Indoor Station Firmware Release Note (2024-11-01)

Device Model	DS-KH8350-WTE1, DS-KH8350-TE1, DS-KH6320-WTE1, DS-KH6320-TE1, DS-KH6320Y-WTE2, DS-KH6320EY-WTE2, DS-KH8520-WTE1, DS-KH6320-WTDE1, DS-KH6320-TDE1
Firmware Version	V2.2.96_build241028

Indoor Station Firmware V2.2.92_build241008 Release Note (2024-10-25)

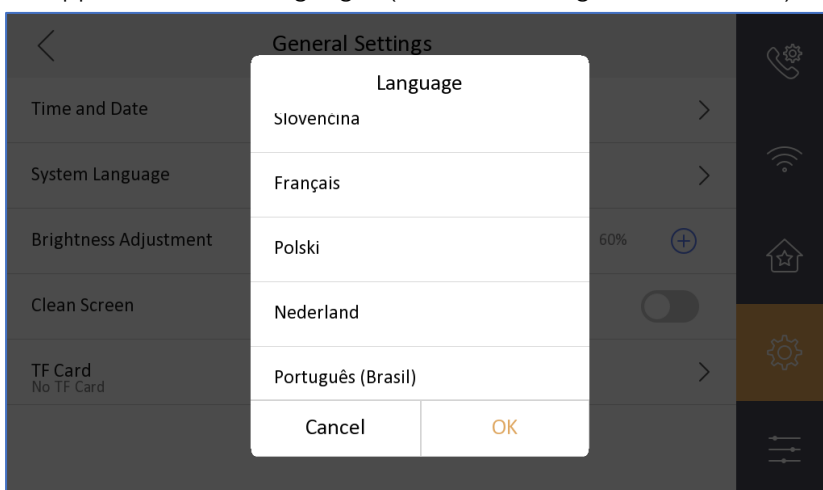
3. Supports C-S registration mode of indoor station and master station.

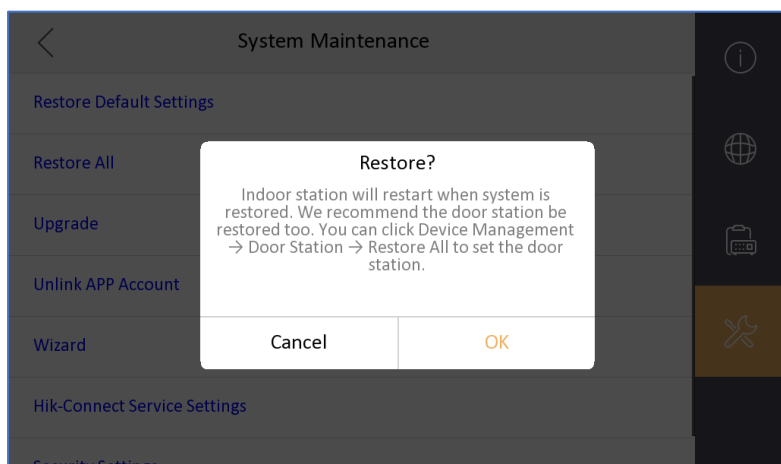
1. Optimizes the maintenance interface with a pop-up window when clicking **Restore** or **Restore All**.

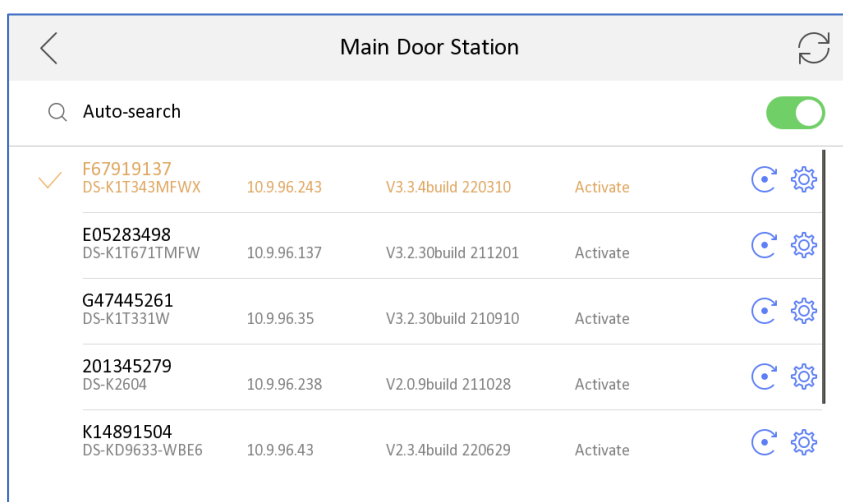
2. Adds the effect of selected door station when relating devices in wizard.

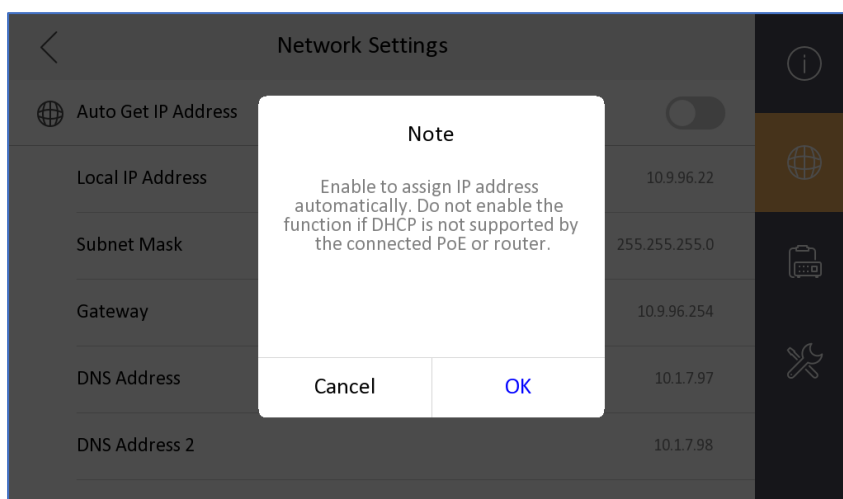
3. Adds a prompt when assigning network IP address automatically.

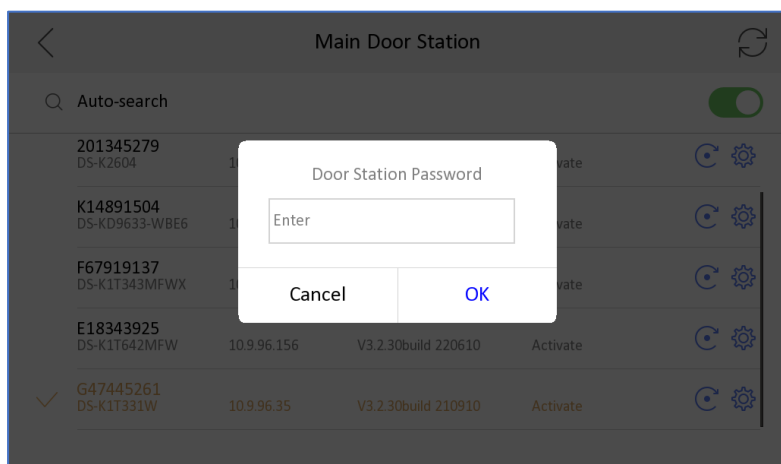
4. In configure wizard to related door station, when the door station password is different from the indoor station, prompt information will pop.

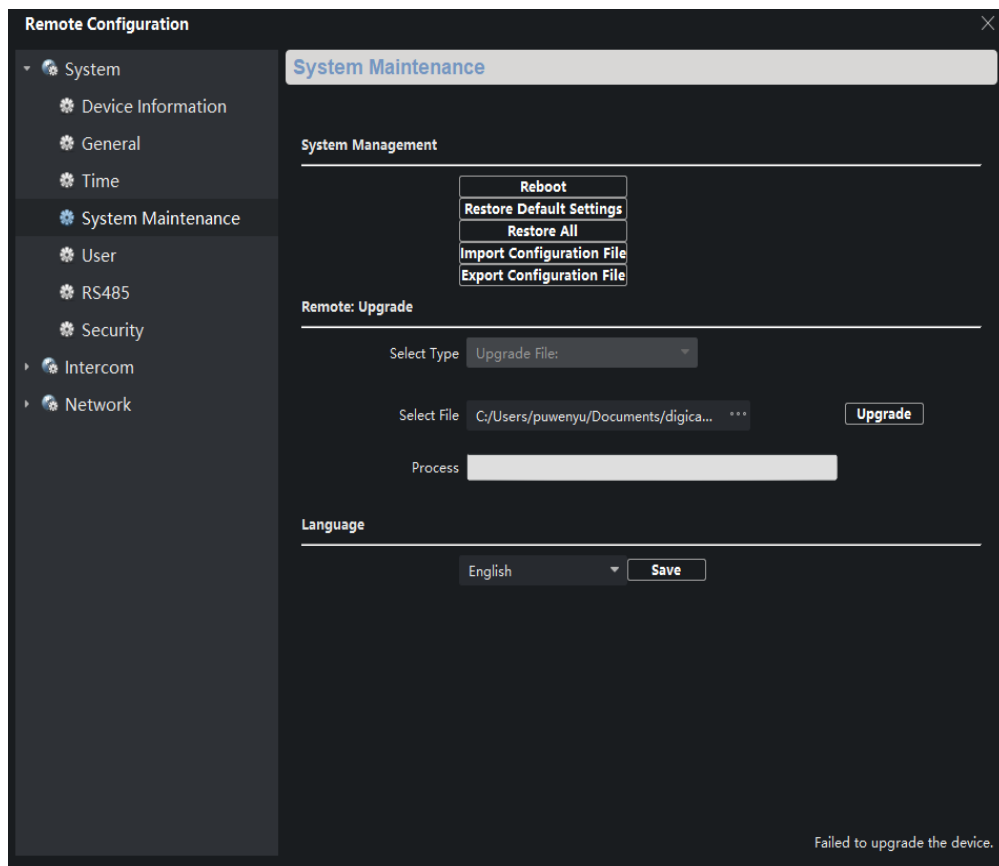
- 1、 Since
V2.1.24
build
210617,
remote

degradation of devices is not supported in all subsequent versions. When degradation occurs, it will prompt Failed to upgrade the device and the device will restart.

Notice: Although the device can be degraded by serial port, the device will fail to start and cannot change the version by using serial port again, which means that the device will be completely unusable.

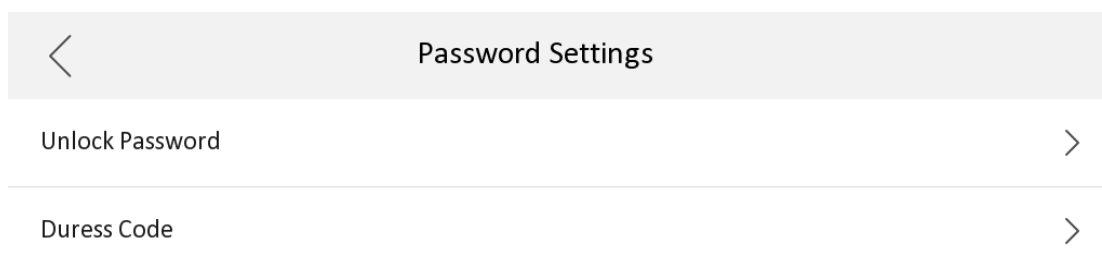
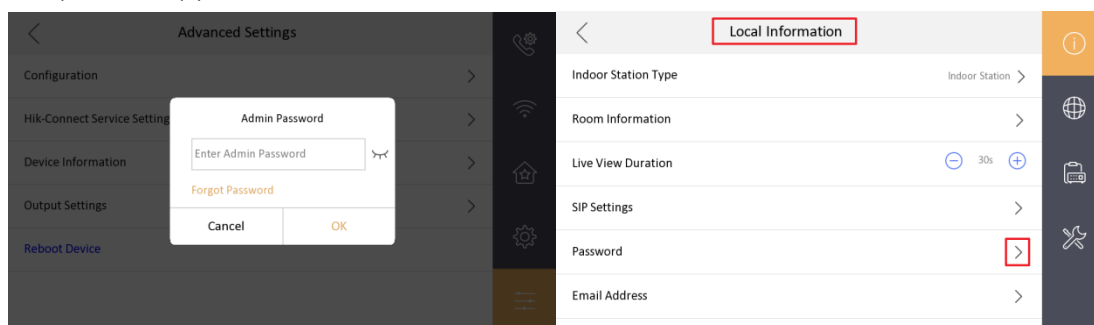
4. Add IPC interface, when Open Network Video Intercom protocol is selected, add plaintext ciphertext switch menu item configuration

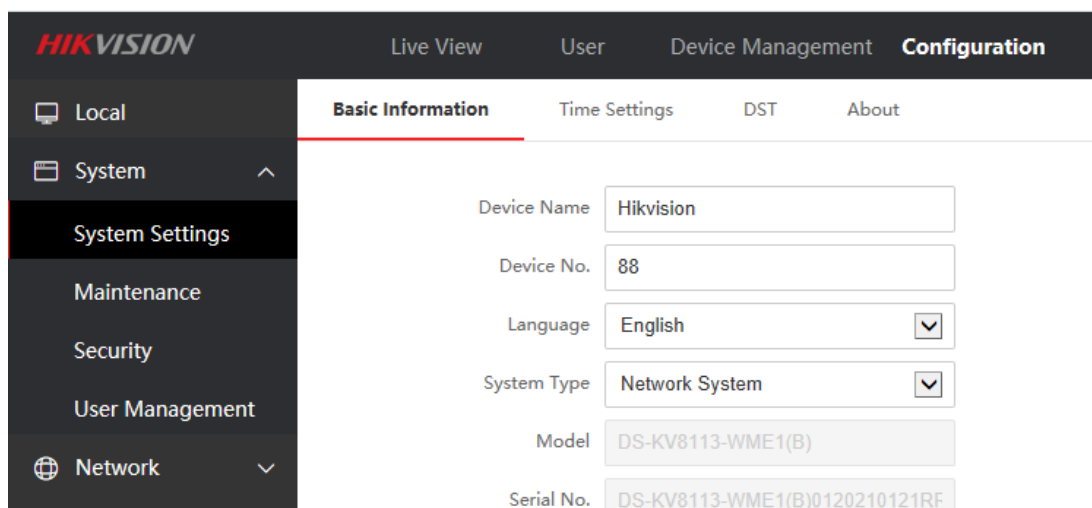
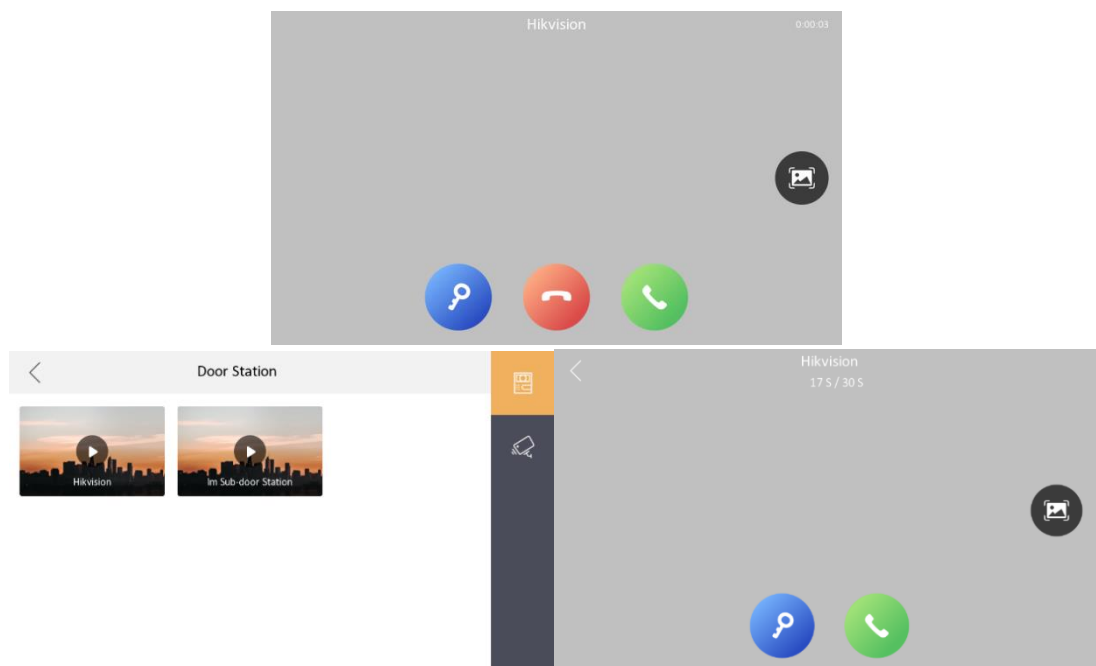
1. Change the position of unlock password and duress code, to enter the password page requires an admin (activation) password.

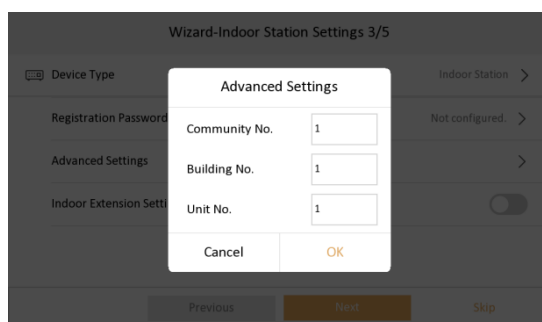
2. When changing the unlock password and duress code, the old password is not required as a credential.
3. The name of the local private SIP password configuration Sip Password is uniformly changed to Registration Password
4. The changed name of the door station(KD8003 modular door station, KV(-B), KB8113) will be displayed on the call interface or live view interface of the indoor station

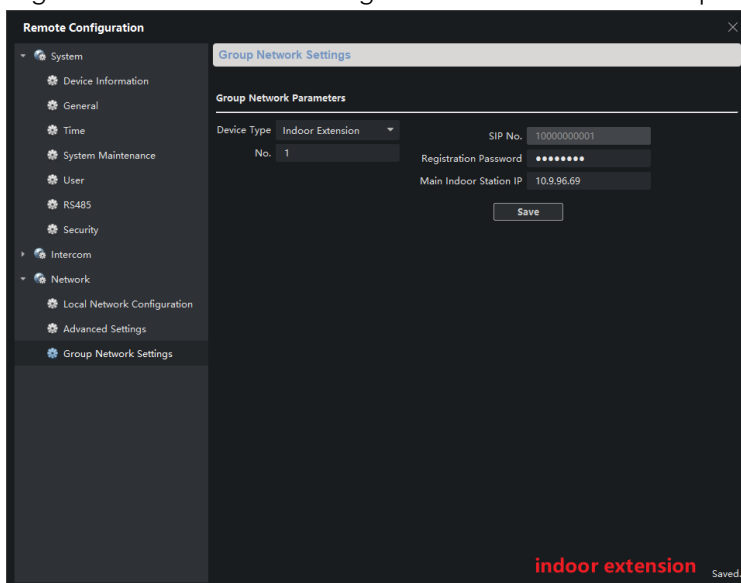
- The local interface community number, building number, and unit number of the indoor station will be stored in the advance column instead of being displayed directly

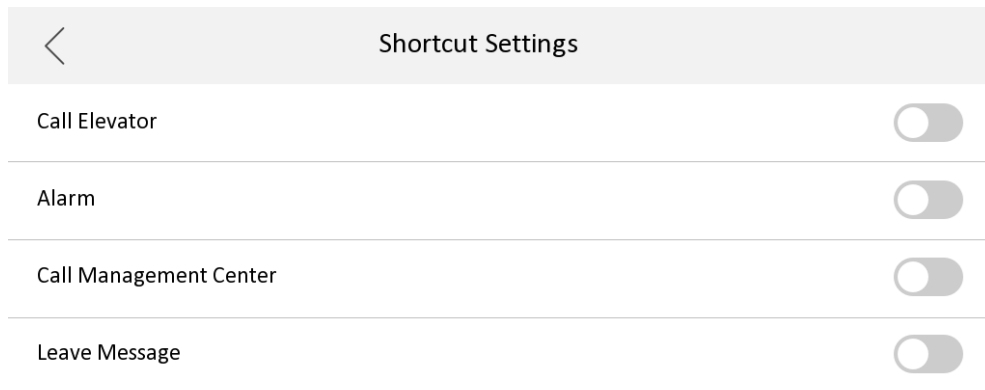
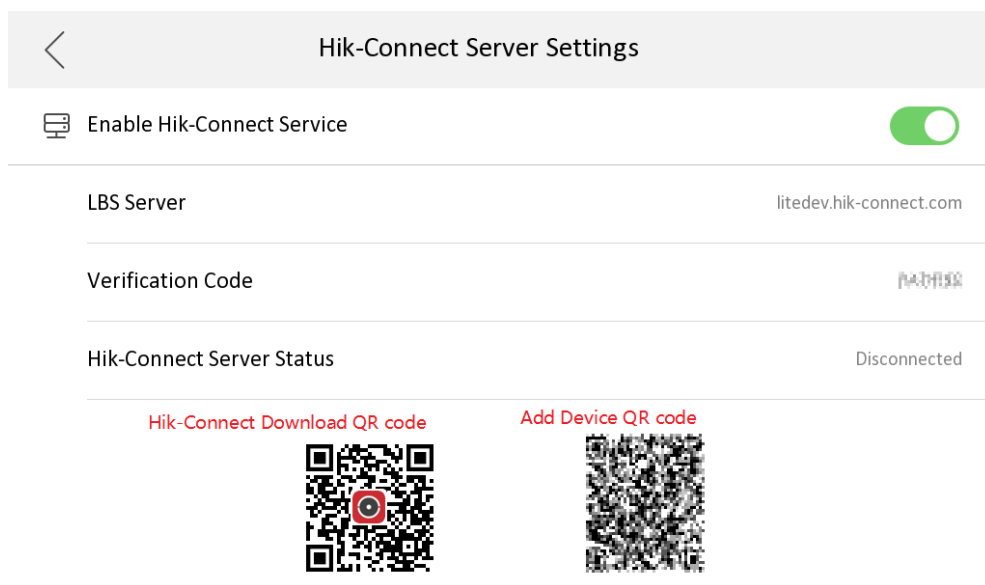
6. Support whether to enable the leave message function, it is disabled by default

1) In the Settings->More->Preference->Shortcut Settings interface

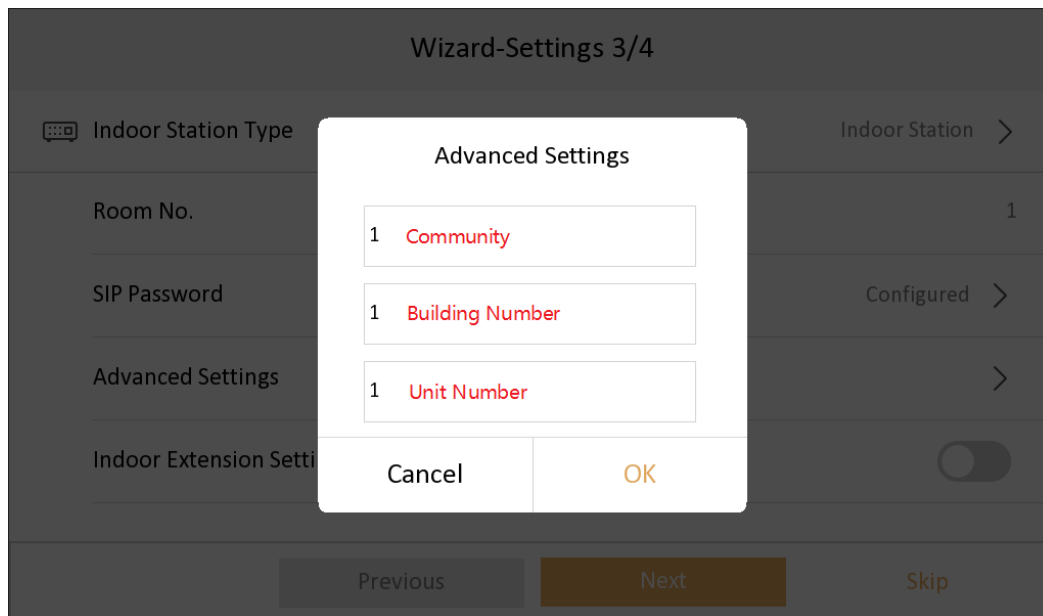
- 1) Support setting period number, building number, and room number on the indoor station;

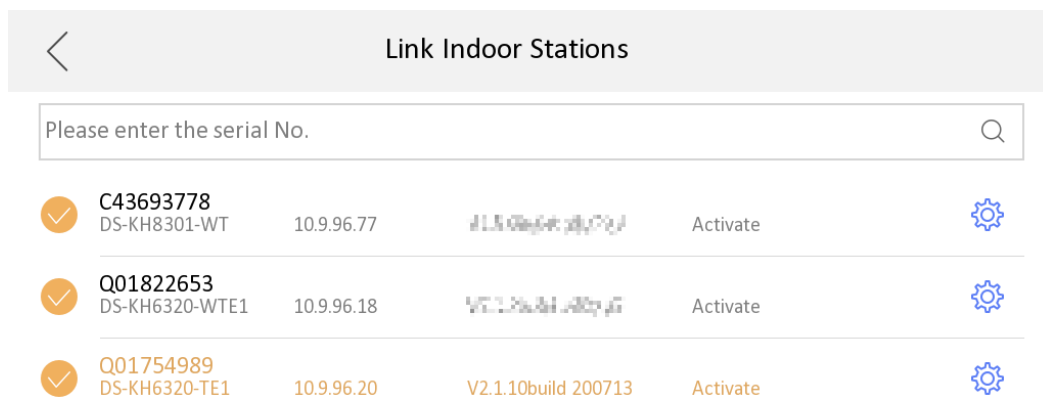
- 2) Support remote configuration of indoor extension information through the main indoor station;

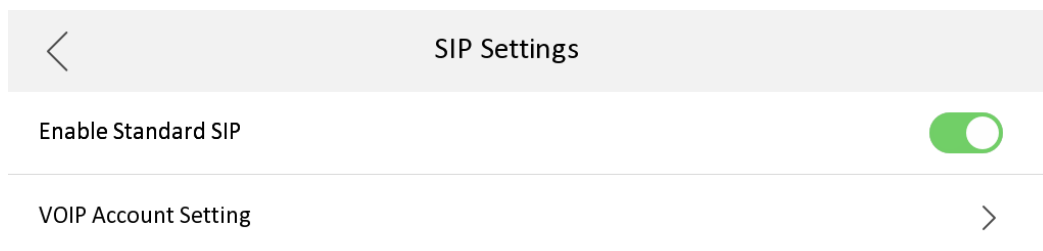
- b) The standard SIP of the indoor station is disabled by default, if you want to connect to a third-party standard SIP device, you need to turn on this function.

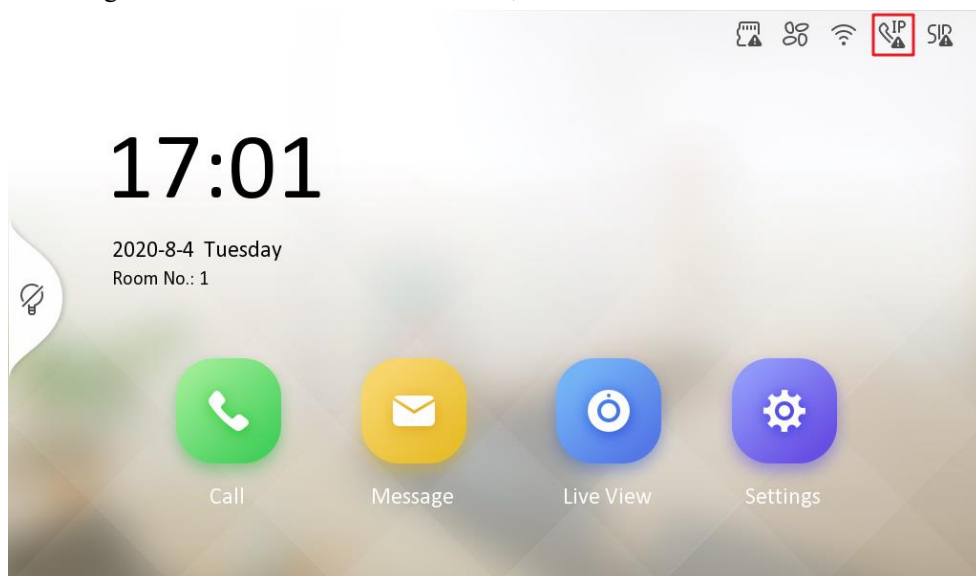
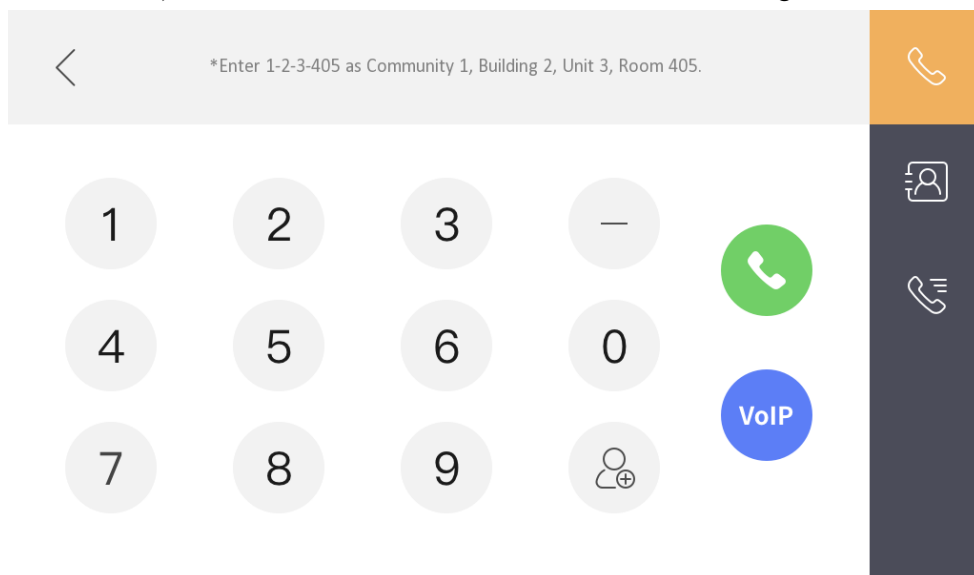
- c) A standard SIP registration status icon is added to the main interface, which can be displayed/hidden

according to whether standard SIP is enabled;
